Response to Submissions Report

**Kembla Grange Resource Recovery Facility
Building Material Storage and
Resource Recovery Facility Exceeding 30,000 Tonnes per Annum and
Redesign and Expansion of Approved Facility**

**Lot 10 DP 878167
50 Wyllie Road, Kembla Grange
Application No. SSD-5300**

**by TCG Planning
20 May 2015**

Figure 1: Drawing C29 Revision B – Site Plan Usage Areas prepared by KFW with overlay of the zone boundary outlined in red.

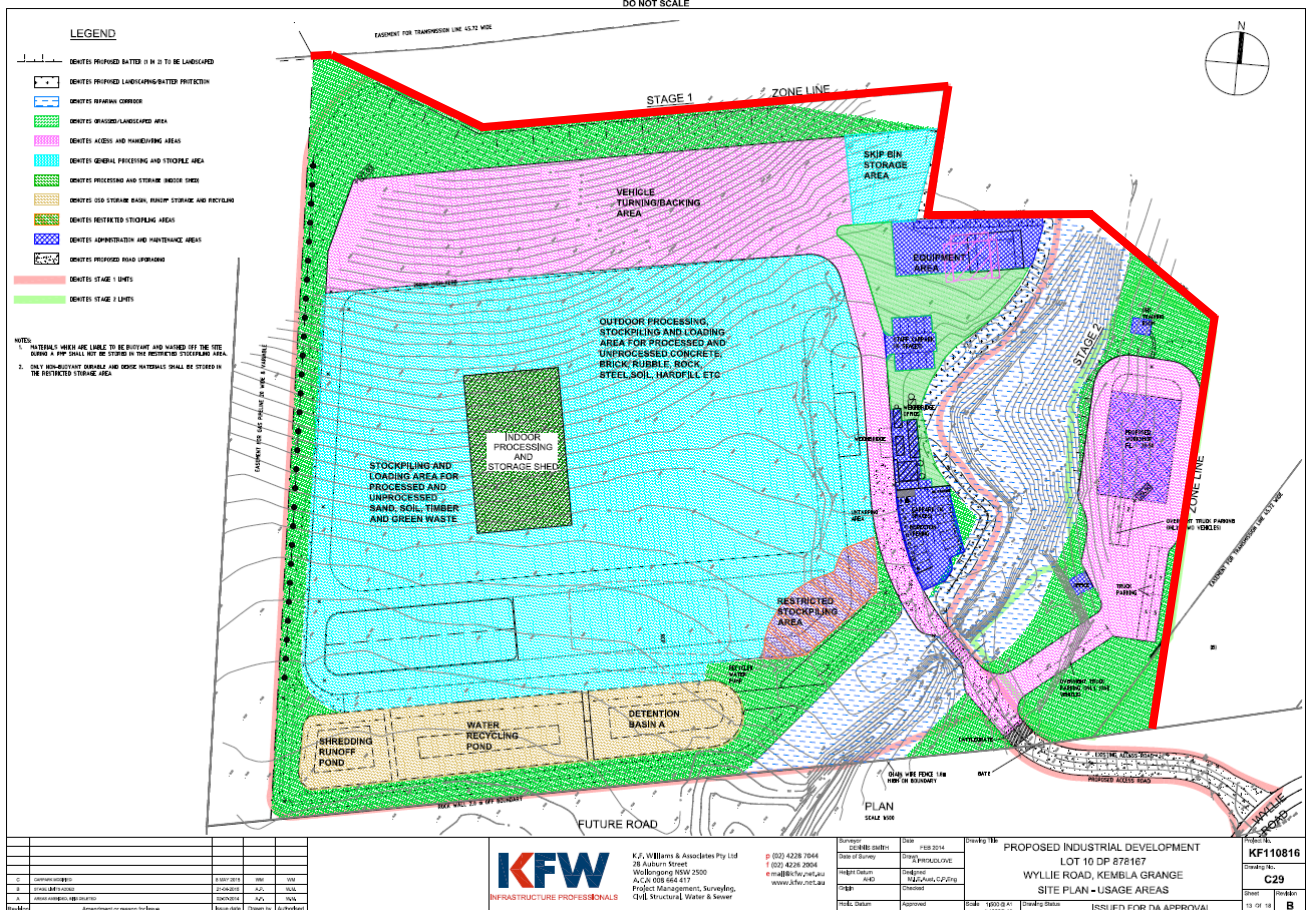
- *"The site is zoned IN2 Light Industrial and RE2 Private Recreation pursuant to Wollongong Local Environmental Plan (LEP) 2009. The proposal is considered to be categorised as a 'resource recovery facility' which is a type of "waste or resource management facility" and is permissible with consent in the IN2 zone. The proposal appears to be wholly located within the IN2 zoned land of the site. Any works associated with the proposed resource recovery facility are to be located in the IN2 zoned portion of the site."*

The site was previously zoned under Wollongong Local Environmental Plan 2010 (West Dapto). Following the consolidation of WLEP 2010 (West Dapto) with WLEP 2009 the subject site is now zoned part IN2 Light Industrial and RE2 Private Recreation under WLEP 2009, as confirmed in Section 7.1.1 of the Environmental Impact Statement dated 17 September 2014. Section 7.1.1 of the EIS confirmed that "the proposed development footprint will be located within the IN2 zone". This is clearly confirmed within Drawing C29 – Site Plan Usage Areas prepared by KFW which contains an overlay of the zone boundary (outlined in red in the **Figure 1** for clarity).

Hence, no modification is required to the footprint of the development, as it has been adequately demonstrated that the development footprint is wholly located within the IN2 Light Industrial zone and is a permissible use. Wollongong City Council concurs with this position.

Figure 2: Predicted - Cumulative Pm₁₀ 24-hour Average Concentration (with mitigation) µg.m³ - Ref: **APRIL 2014** (now superseded) Ref: Air Quality Assessment (Figure 15), GHD

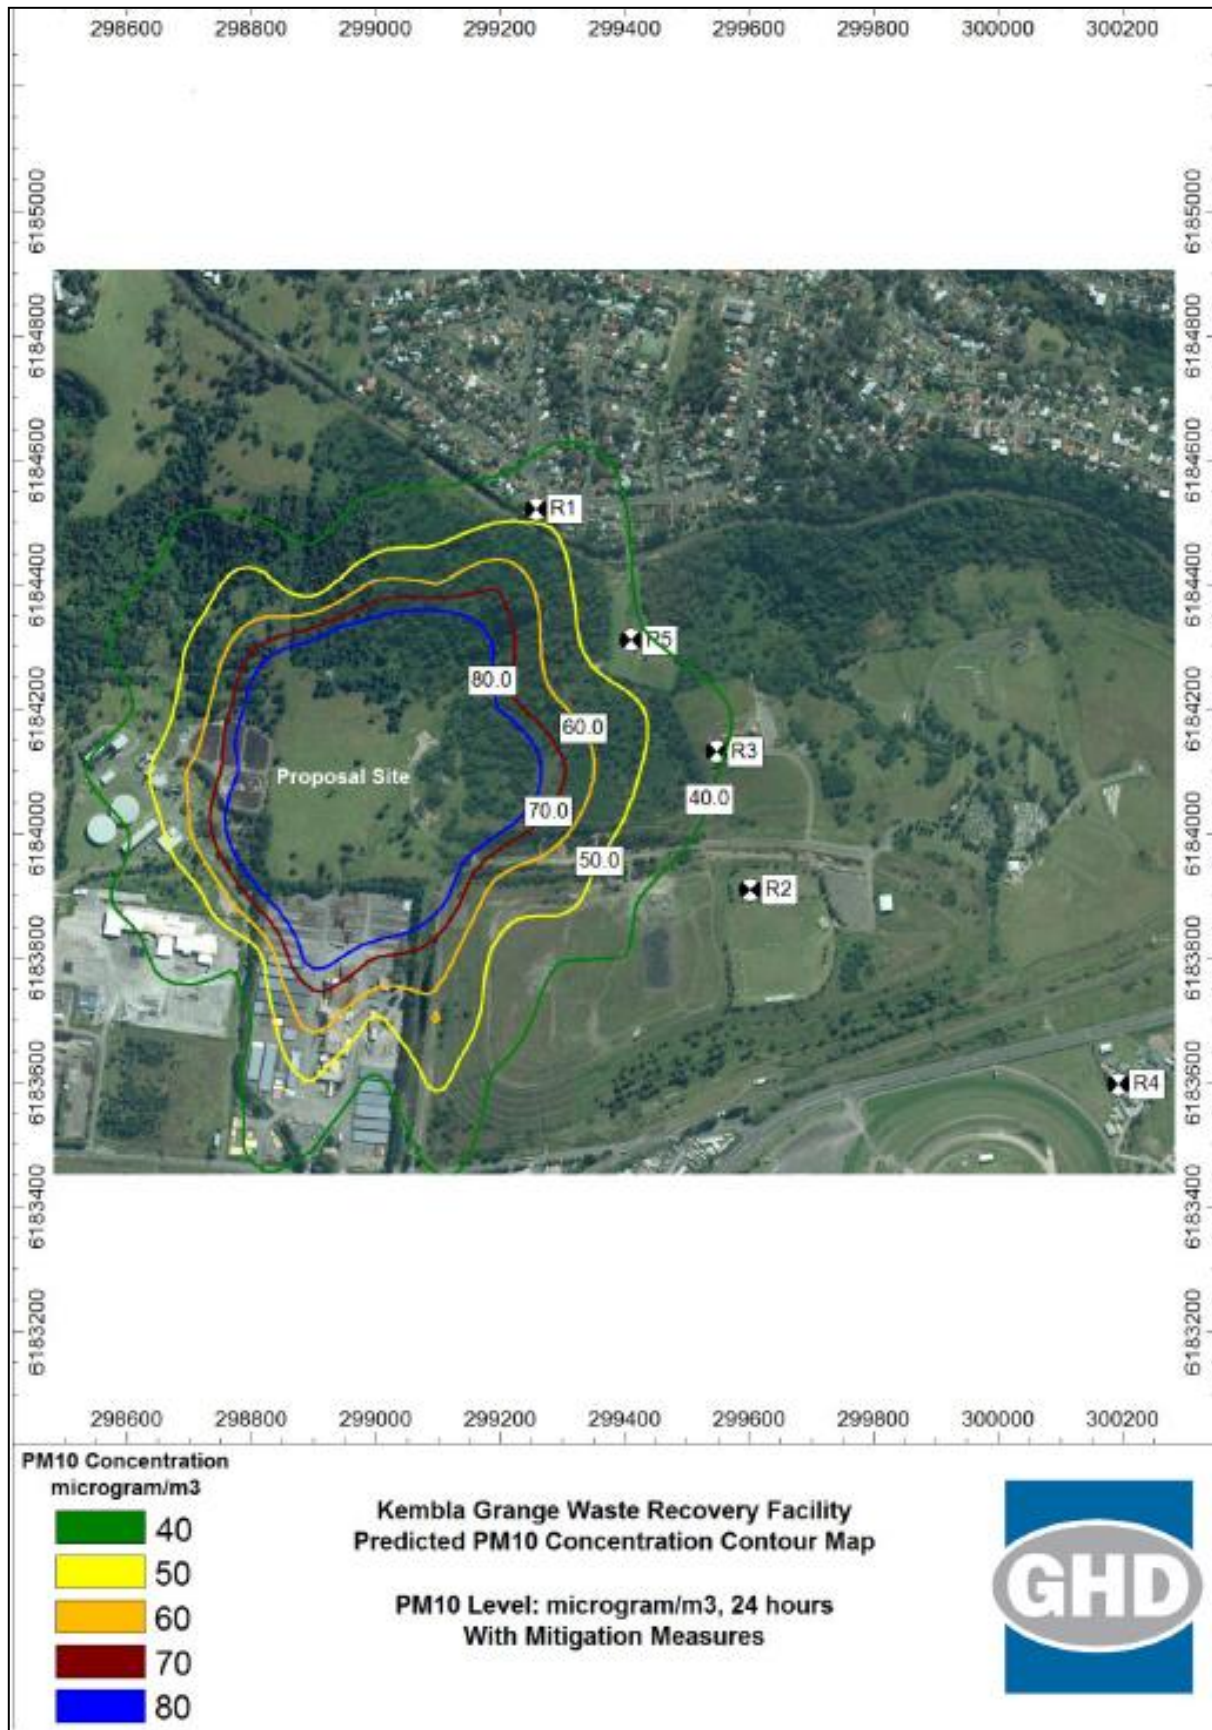
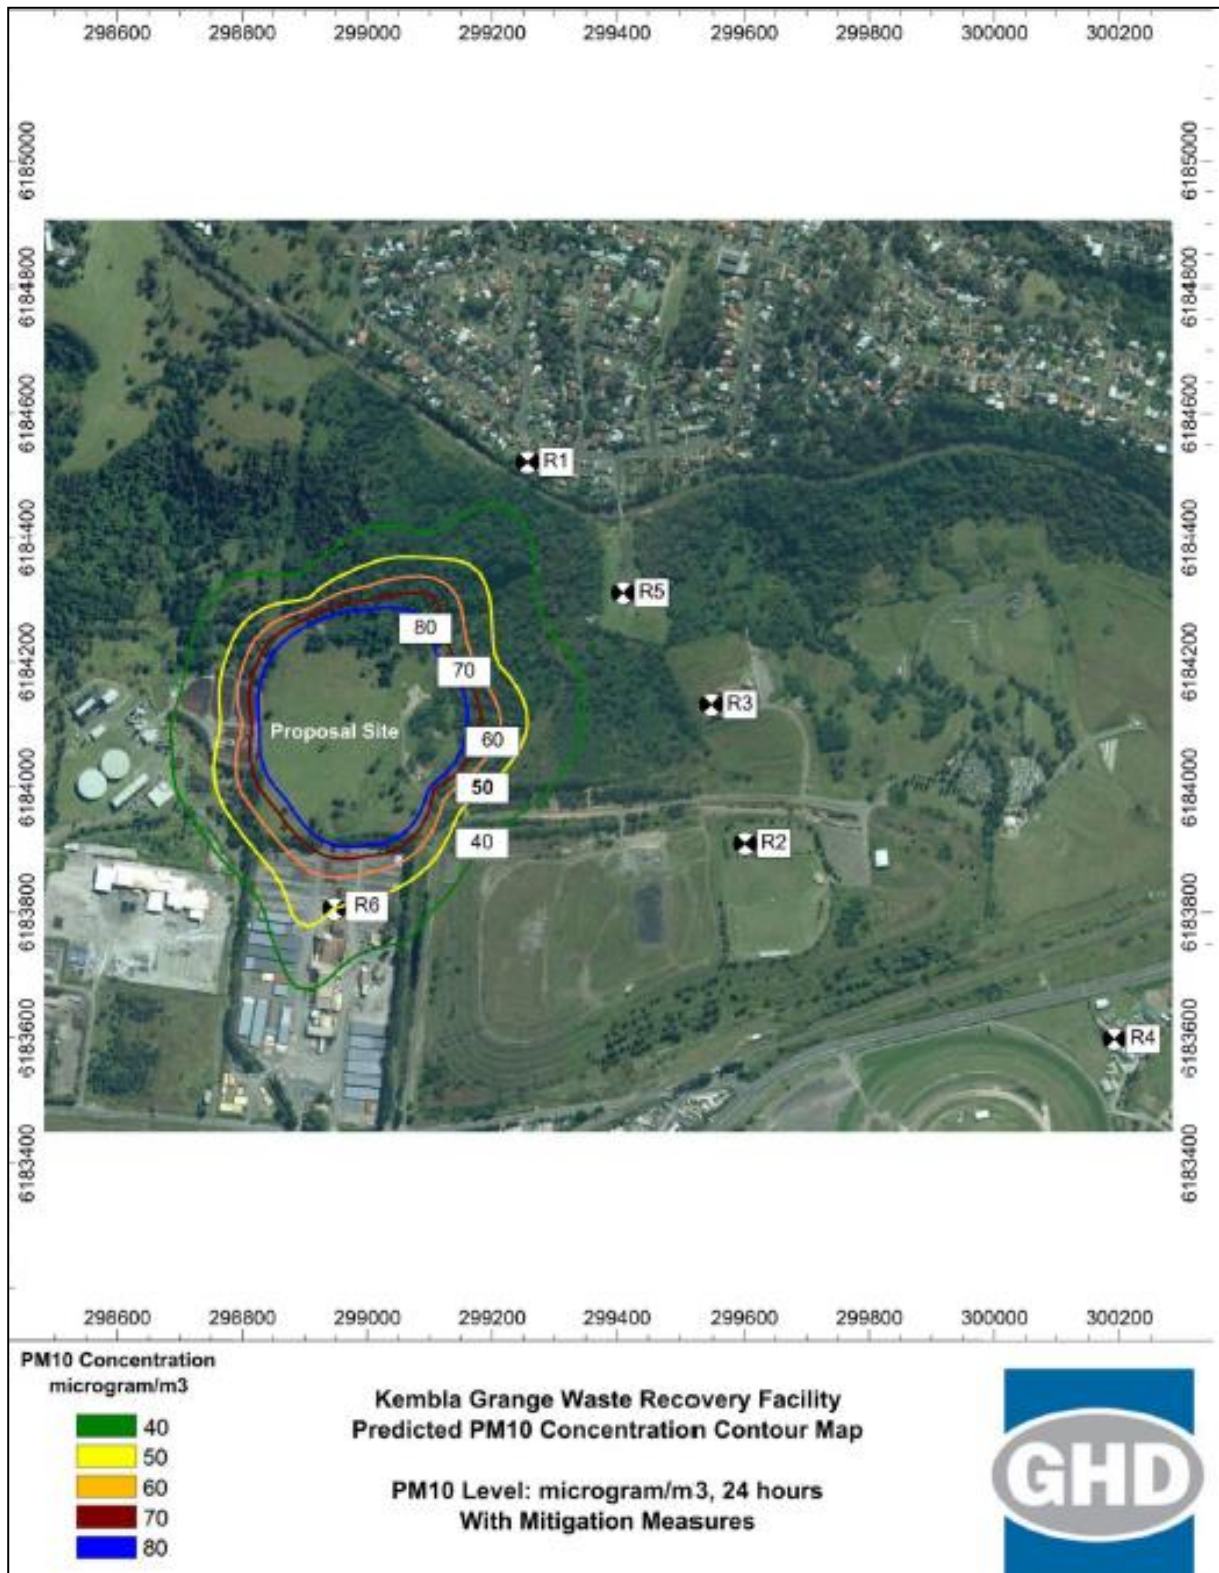
With respect to Figure 15 Cardno had previously noted that the PAC site at 66 West Dapto Road will be exposed to a maximum 24 hour average of 50 to 80 micrograms per cubic metre of PM₁₀ particles and that approximately half the site area would be exposed to PM₁₀ concentrations of 50 micrograms per cubic metre or more. The impacts at 17 Reddalls Road would be between 40 and 70 micrograms per cubic metre. Such levels are based on the contours contained in the July 2014 version of the AQA. In comparison, the April 2015 version now confirms that the PAC site at 66 West Dapto Road will be exposed to a much lesser extent, with only a minor portion of the site being affected by levels of between 60 to 80 micrograms per cubic metre. Less than half the site is now affected by levels of between 40 micrograms per cubic metre, with the majority of this portion being in the range of 40 to 60 micrograms per cubic metre. The revised contours contained in Figure 15 of the April 2015 AQA (reproduced as Figure 3 in this RTS) also confirm that, with the additional mitigation, No. 17 Reddalls Road will not be affected by PM₁₀ particles.

When comparing the contours in Figures 15 (Predicted - Cumulative PM₁₀ 24-hour Average Concentration (with mitigation ug/m³)) of the July 2014 AQA with Figure 15 of the April 2015 AQA a lesser level of impact is evident, due to the incorporation of additional mitigation measures, including chemical spraying, within the April 2015 modelling. The July 2014 report modelled only mitigation measures in the form of Level 2 water sprays. A similar level of improvement is also evident from the contours contained in Figure 16 (Predicted - Cumulative TSP Annuals Average Concentration (with mitigation) ug/m³ in the July 2014 AQA and those contained in Figure 16 of the April 2015 AQA. The comparative contours as contained in Figures 15 and 16 of the GHD reports of July 2014 and April 2015 are contained in Figures 2 to 5 of this Response to Submissions.

Figure 4: Predicted- Cumulative TSP Annual Average Concentration (with Mitigation) $\mu\text{g.m}^{-3}$ - **APRIL 2014** (now superseded) Ref: Air Quality Assessment (Figure 16), GHD

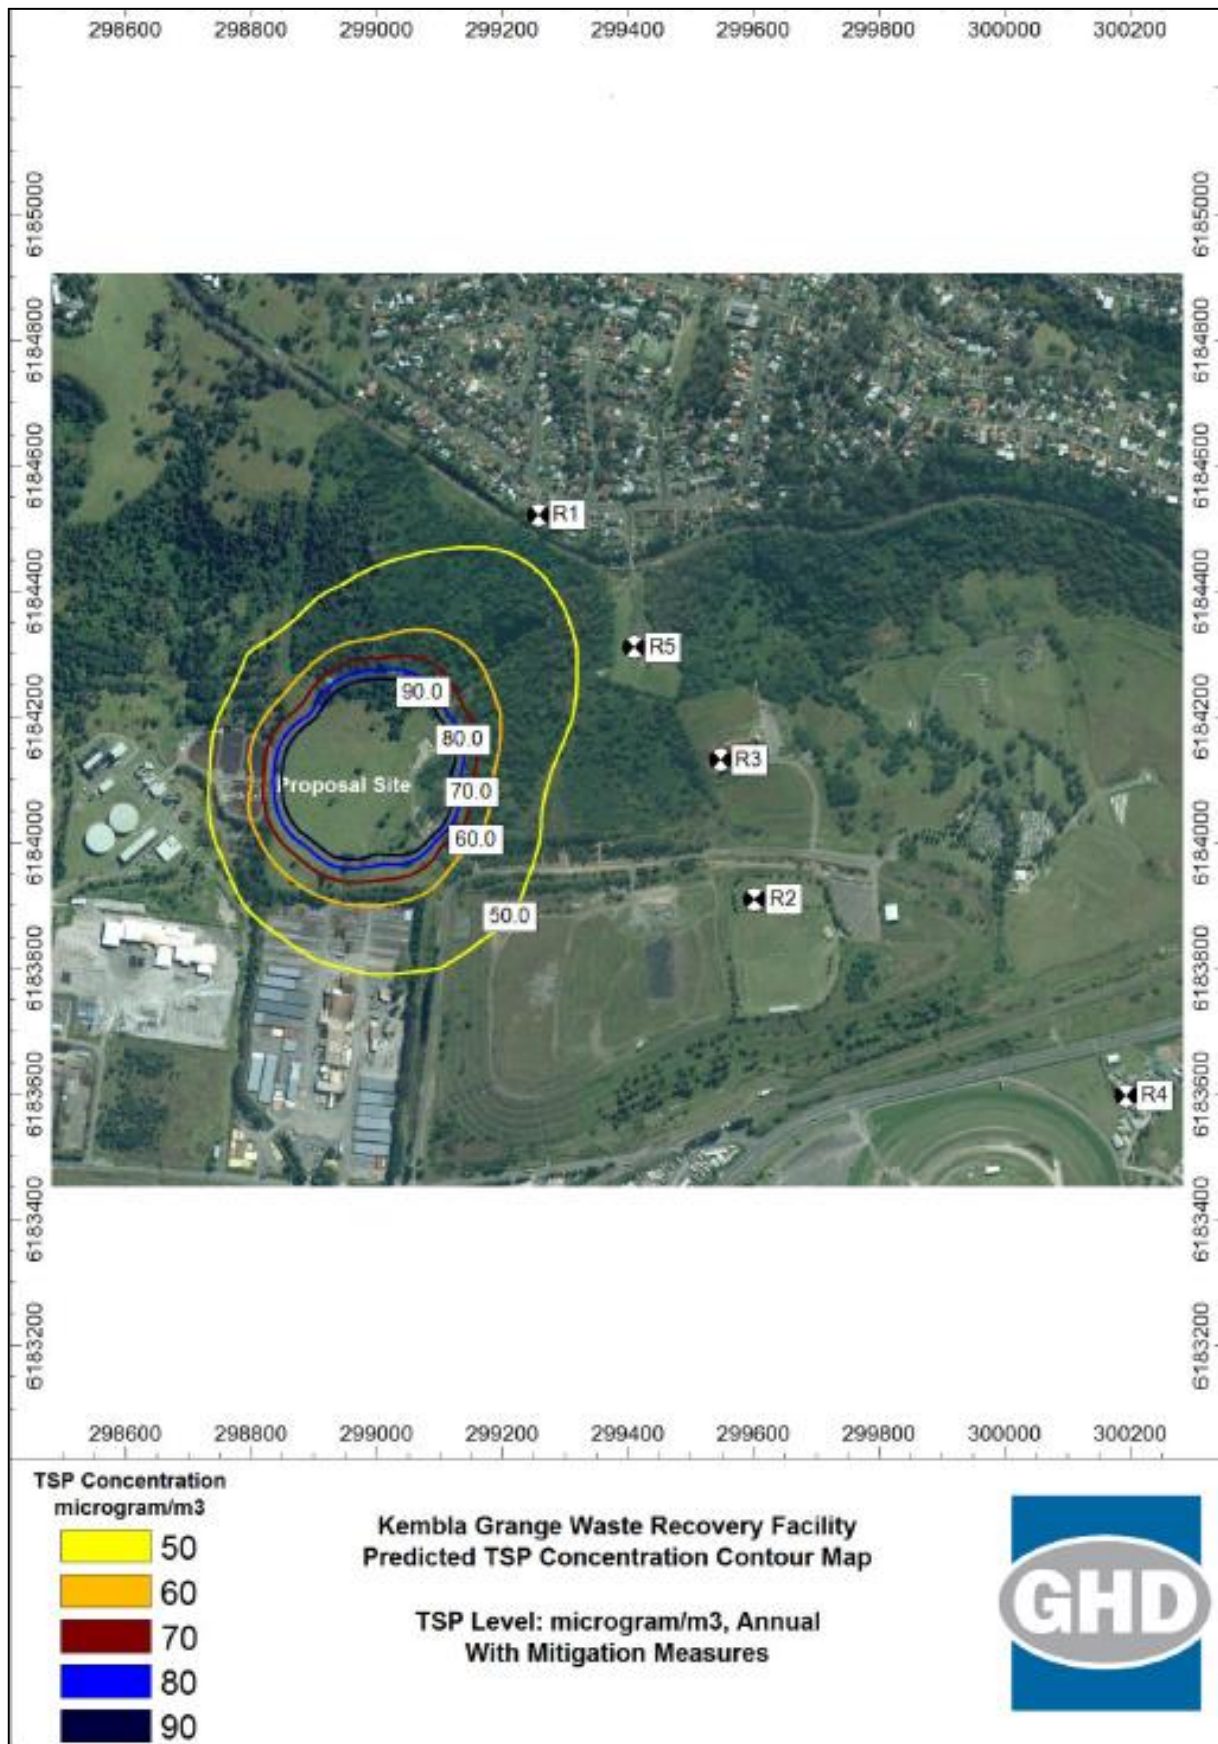
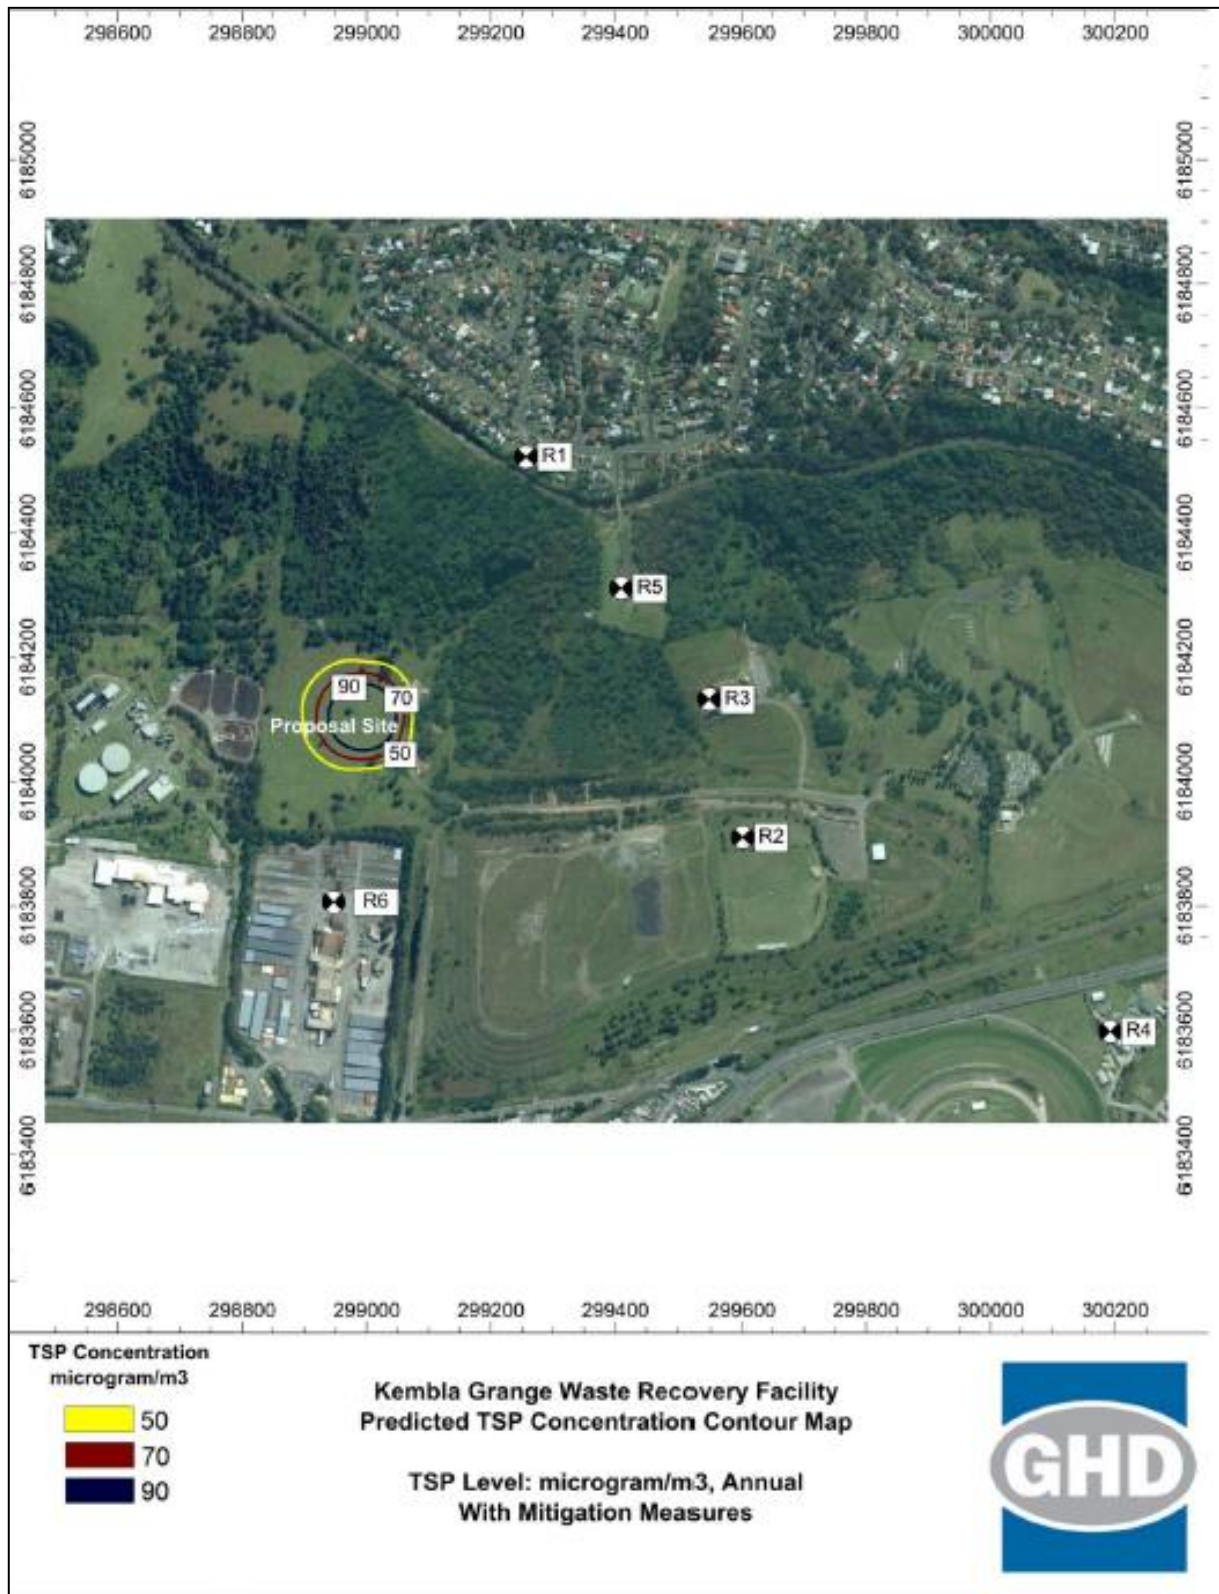
Cardno also raised concern that the predicted annual average concentration of TSPs will rise to between 50 and 60 micograms per cubic metre on the northern quarter of PAC's facility at 66 West Dapto Road even with all proposed mitigation measures implemented. In response to this, it is noted that following modelling to include the additional mitigation measures Figure 16 of the AQA dated April 2015 (reproduced as Figure 5 in this RTS) now shows that all adjacent sites, including the sites at No. 66 West Dapto Rd and 17 Reddalls Road will comply with TSP concentration levels.

The additional mitigation measures (ie chemical spraying) which have been included in the revised assessment confirm (in Table 14 reproduced as Table 5 of this RTS) that the criteria for dust impact at all sensitive receivers is met with mitigation, including PM10 particles at the Patrick Autocare site. The April 2015 AQA also now includes an additional figure (Figure 17) which demonstrates this by detailing the predicted annual dust deposition contours for the facility with mitigation. Figure 17 of this report is reproduced in Figure 6 of this RTS. GHD note within the AQA that "to be conservative, the receptor location for dust deposition has been assumed to be the northern boundary of the Patrick Autocare property", rather than the offices where the criteria would generally apply.
